M-9A0 (Calpella + N11P/M Discrete Graphic)

FOXCONN		HON HAI Precision Ind. Co., Ltd.	
Title		CCPBG - R&D Division	
Size		Document Number	
Custom		M9A0 MP	
Date:		Wednesday, October 28, 2009	Sheet 5 of 73
		Rev 1.1

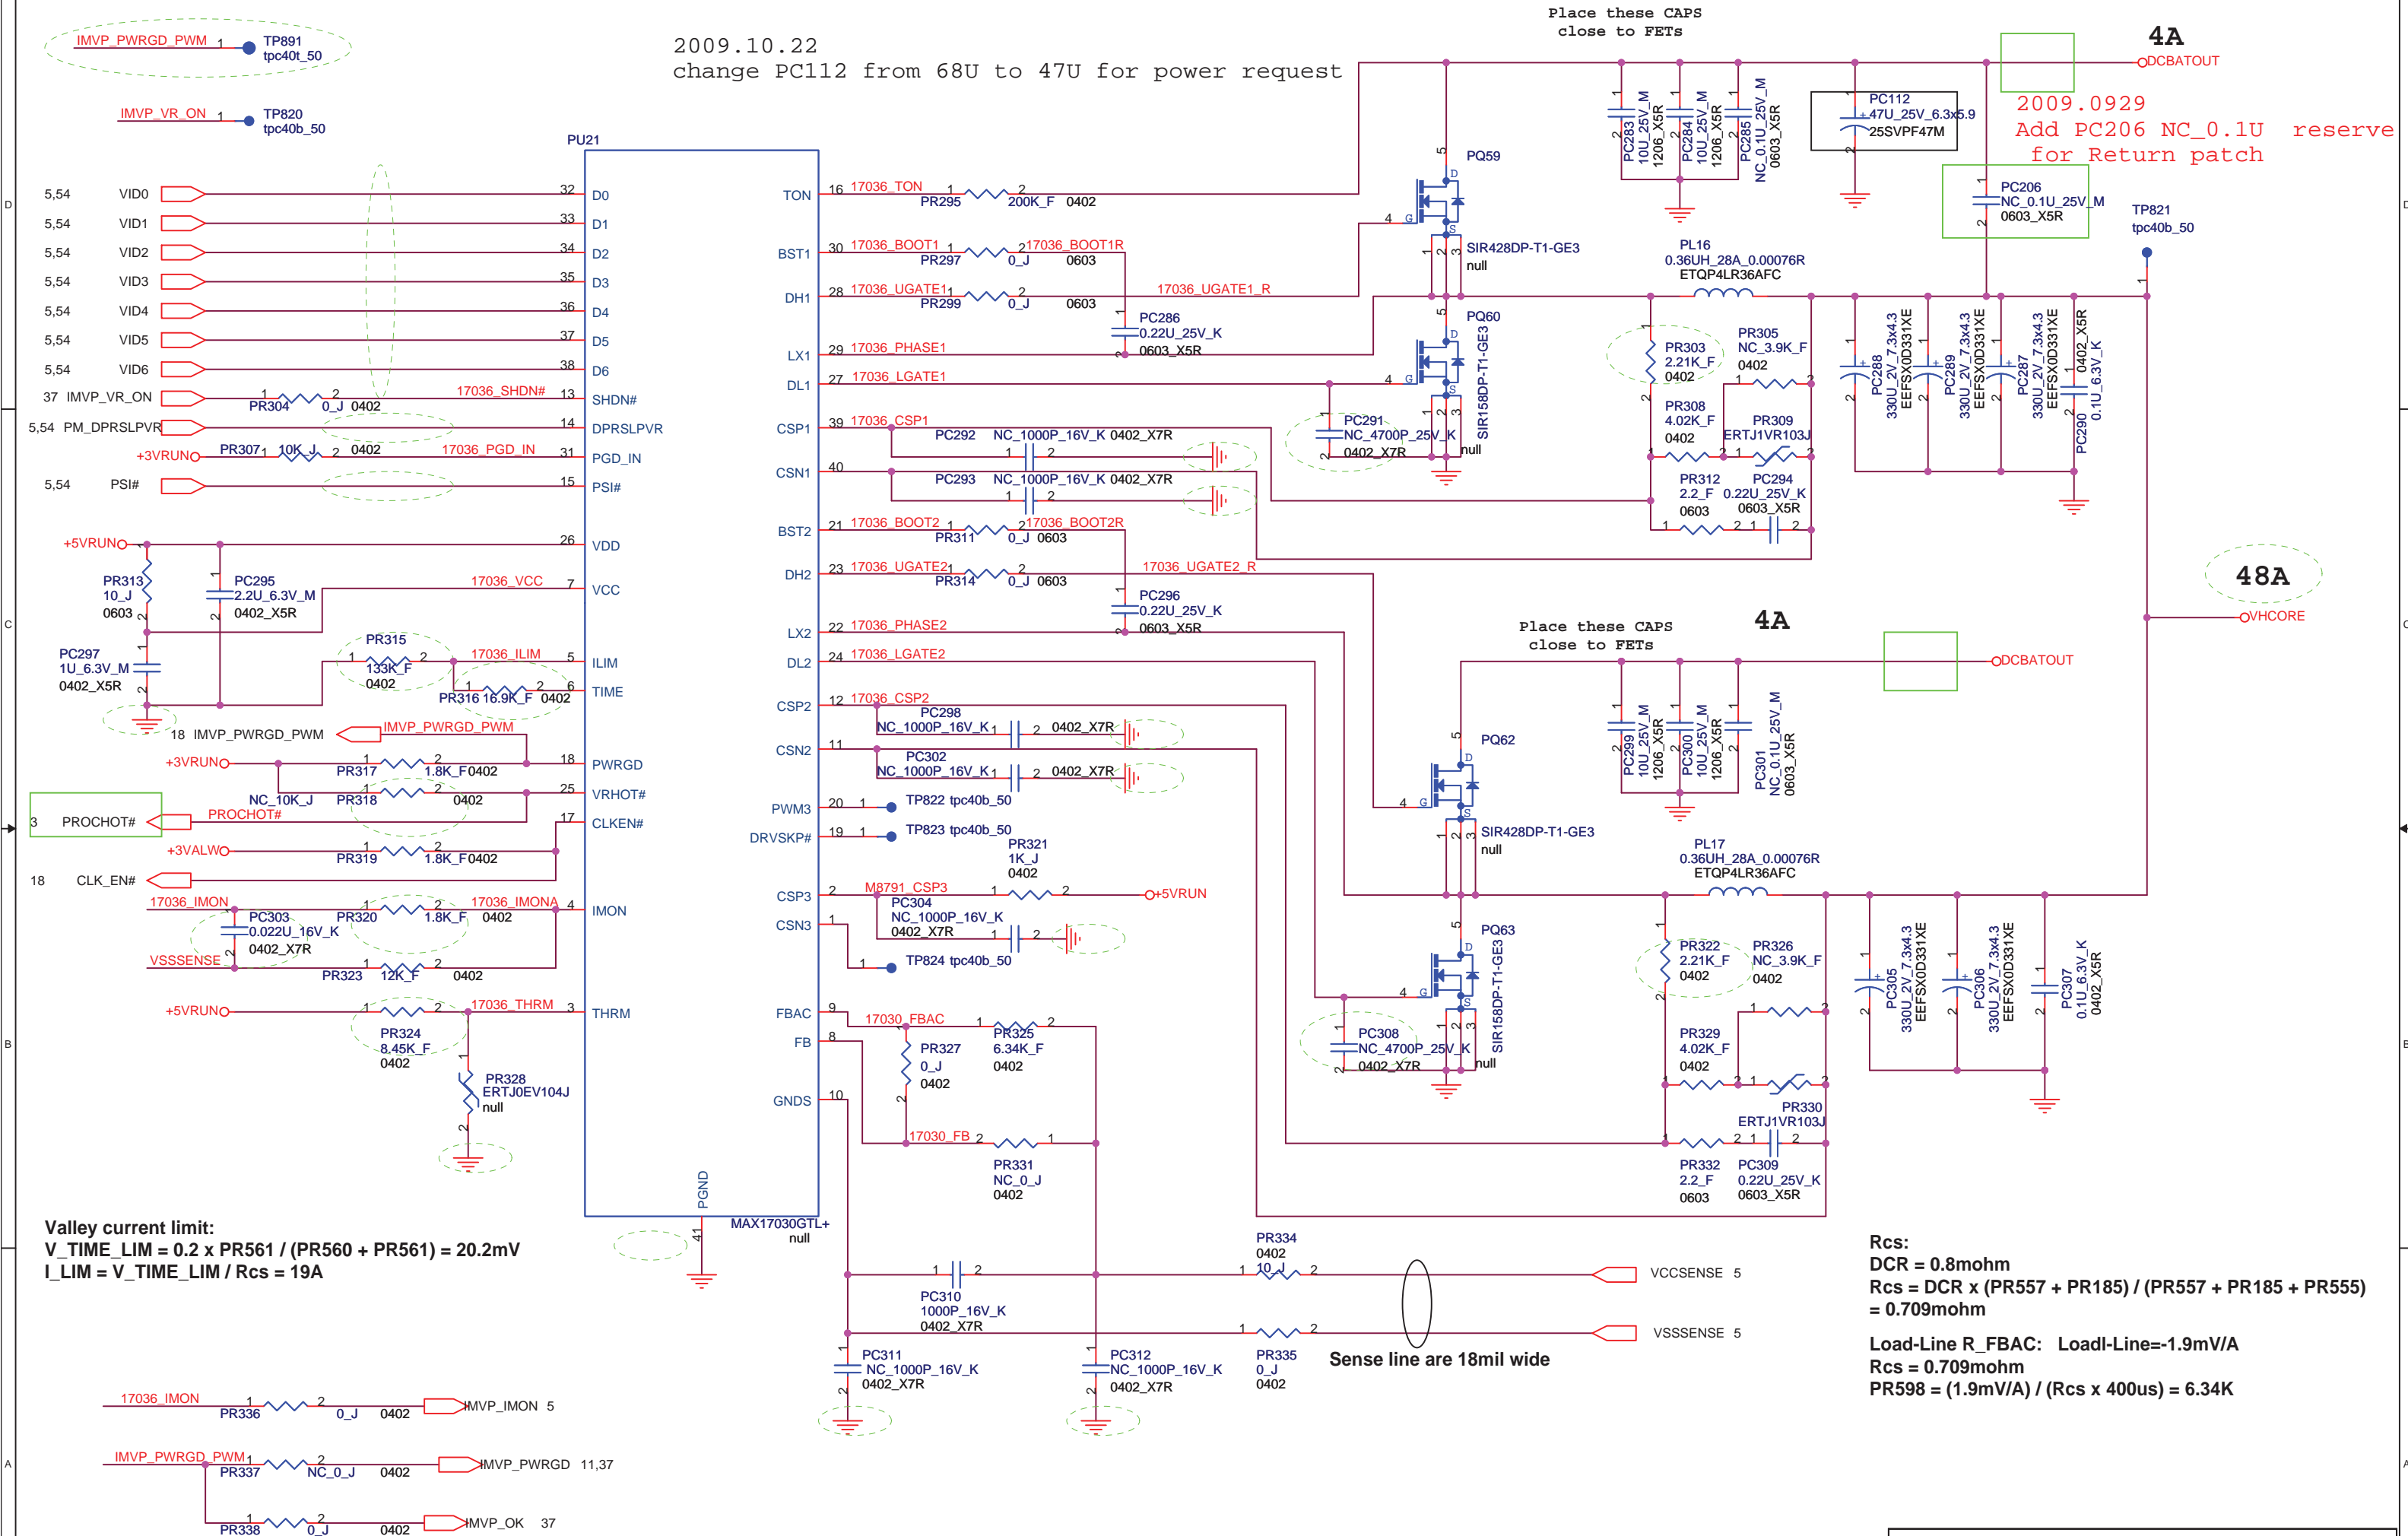
2009.10.22
change PC112 from 68U to 47U for power request

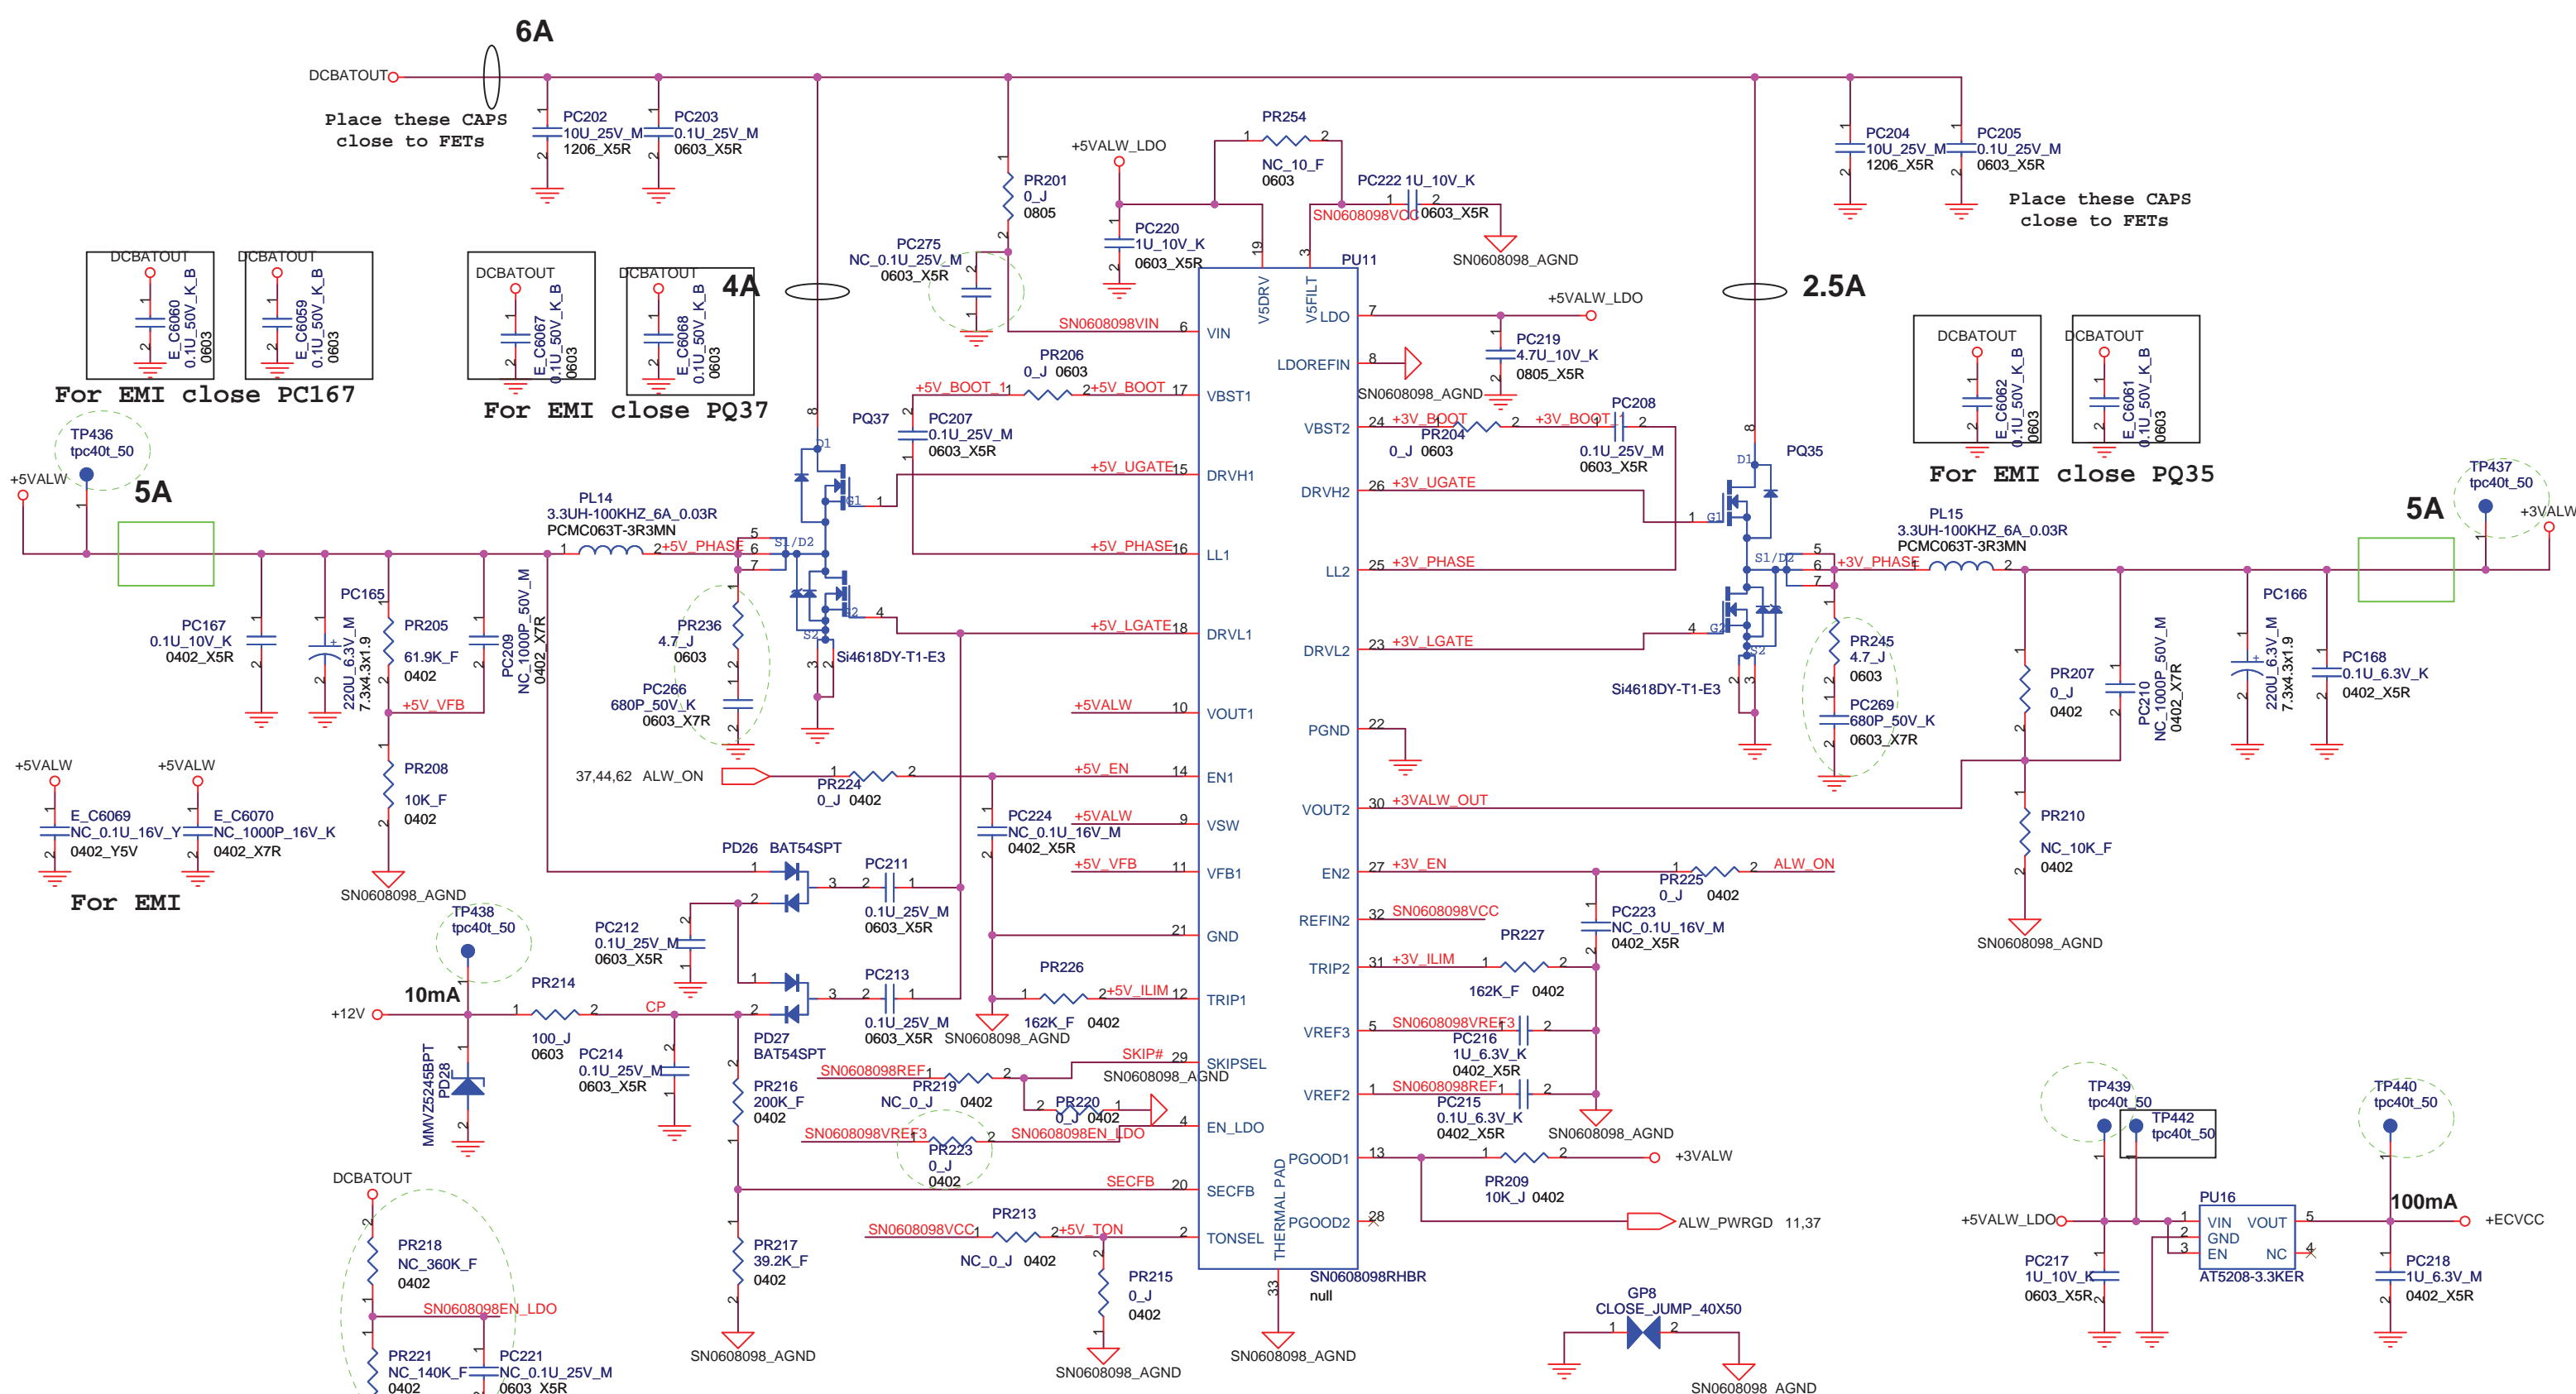
2009.0925
change PR245,PC269,PR236,PC266 from NC to mount for EMI request

SPEAKER AMP

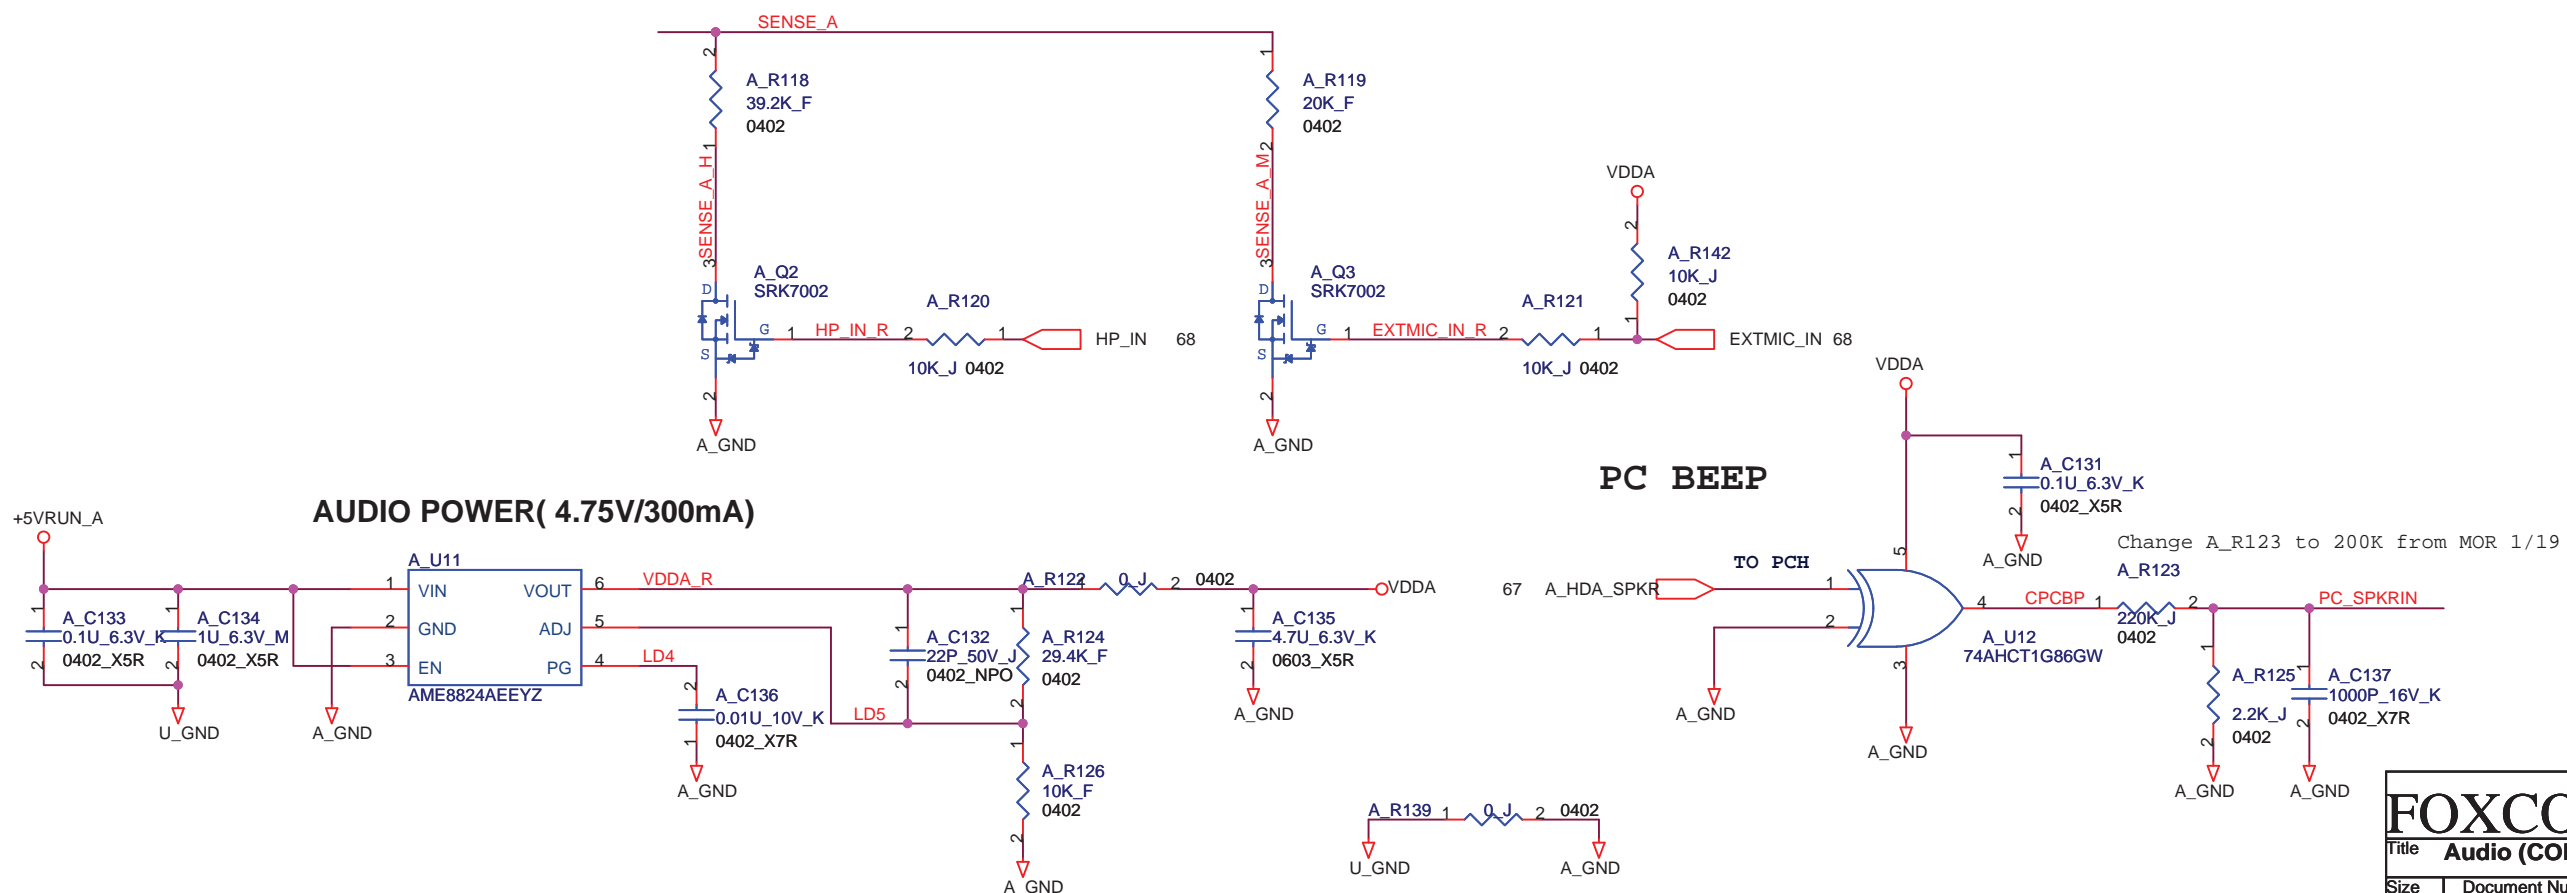
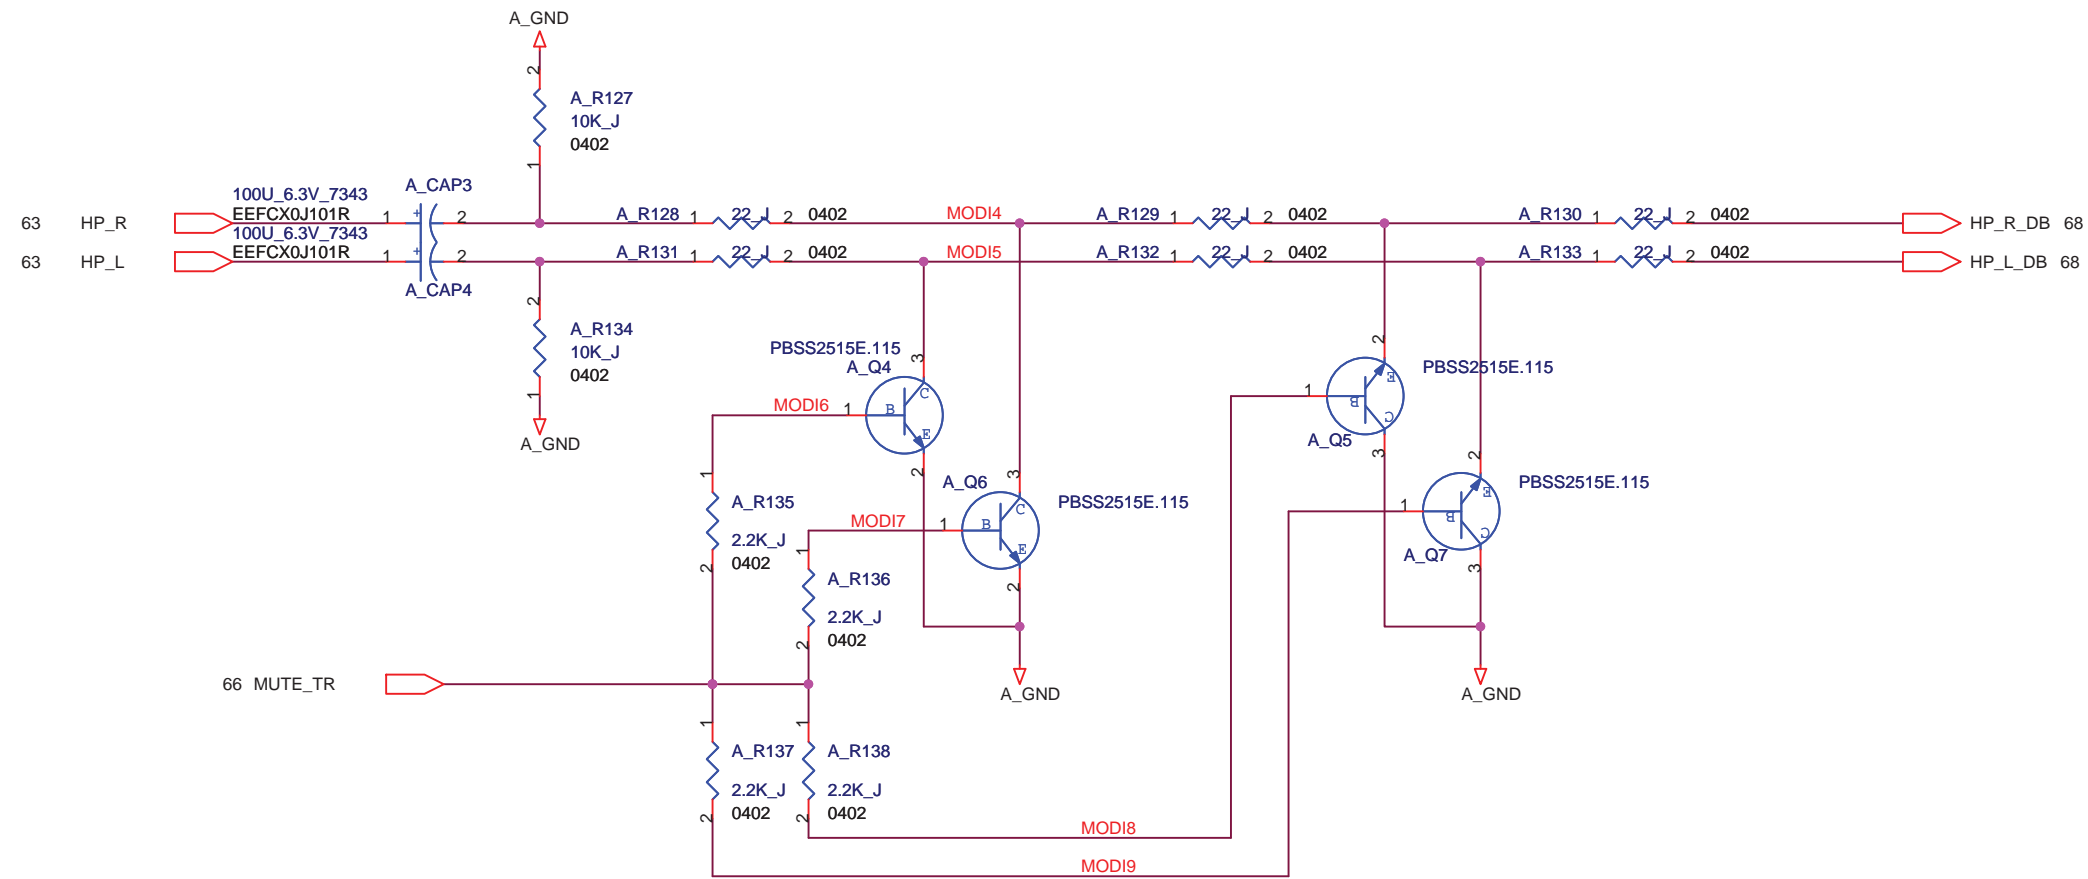
2009.11.03
change A_C23,A_C22 from 15PF to 22PF for EMI request
